SERVICE LETTER

No. 369

Piper Aircraft Corporation

SUBJECT: Inspection of Brake Cable and Pulleys

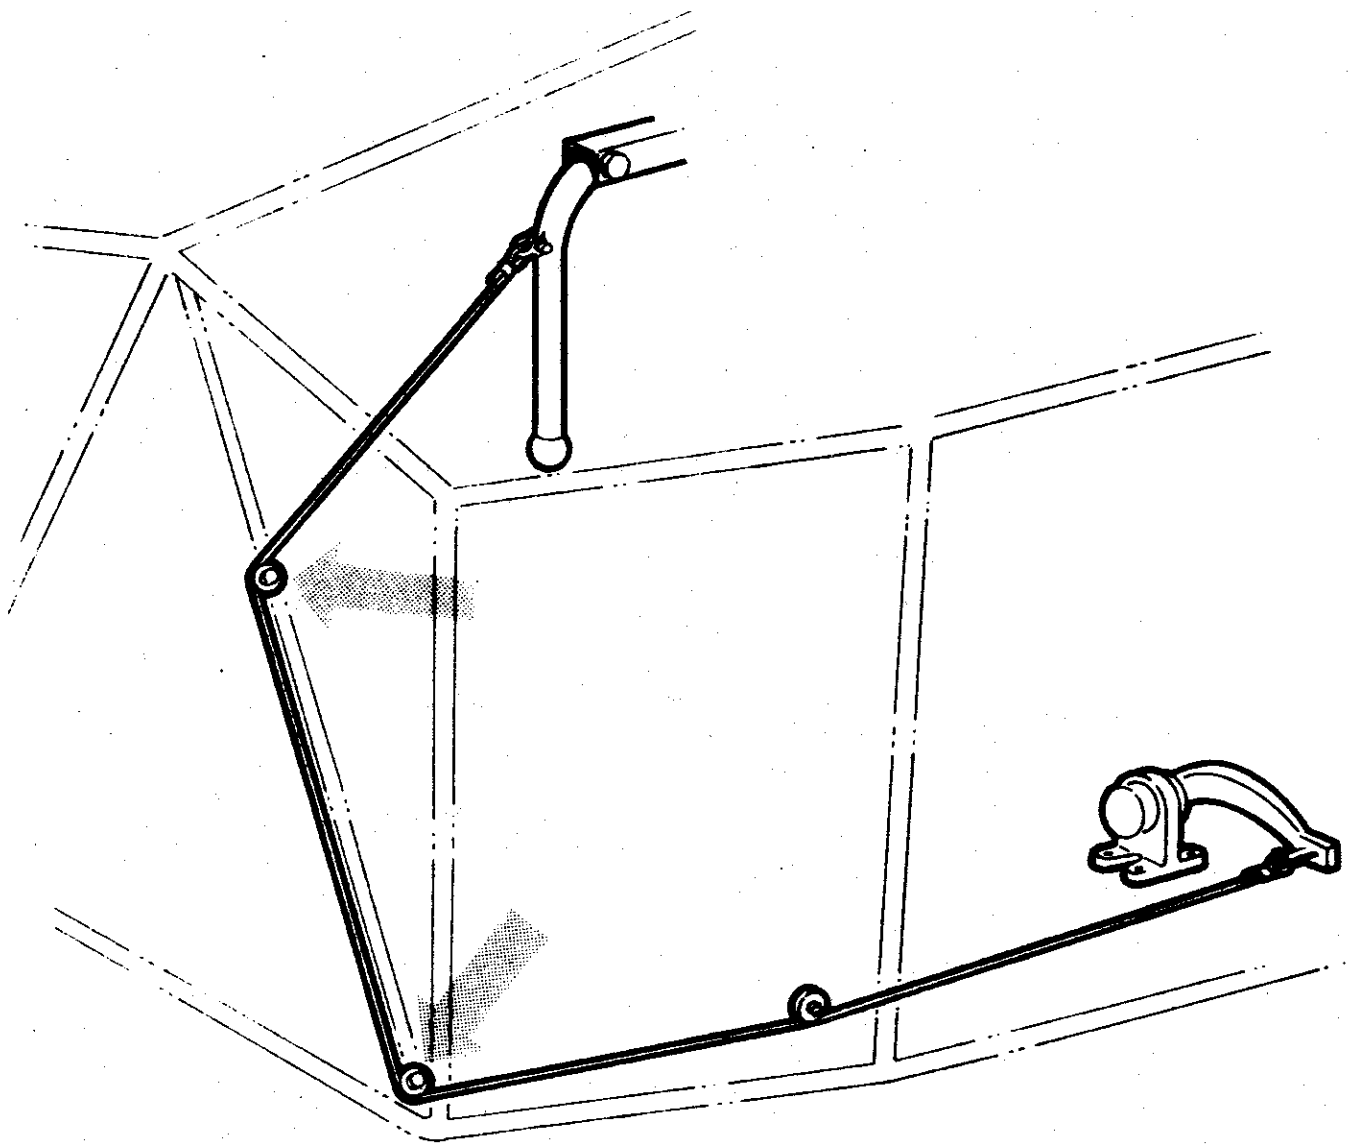
Service experience would tend to indicate that a closer inspection of the brake cable and pulleys is necessary in the subject aircraft. A number of reports of frayed or broken cables, generally where the cable contacts the pulleys, have been received.

It is suggested that an immediate inspection be made of the general areas indicated on the sketch on the reverse side of this letter. This area should be included in all subsequent routine inspections.

Inspect brake cable where indicated
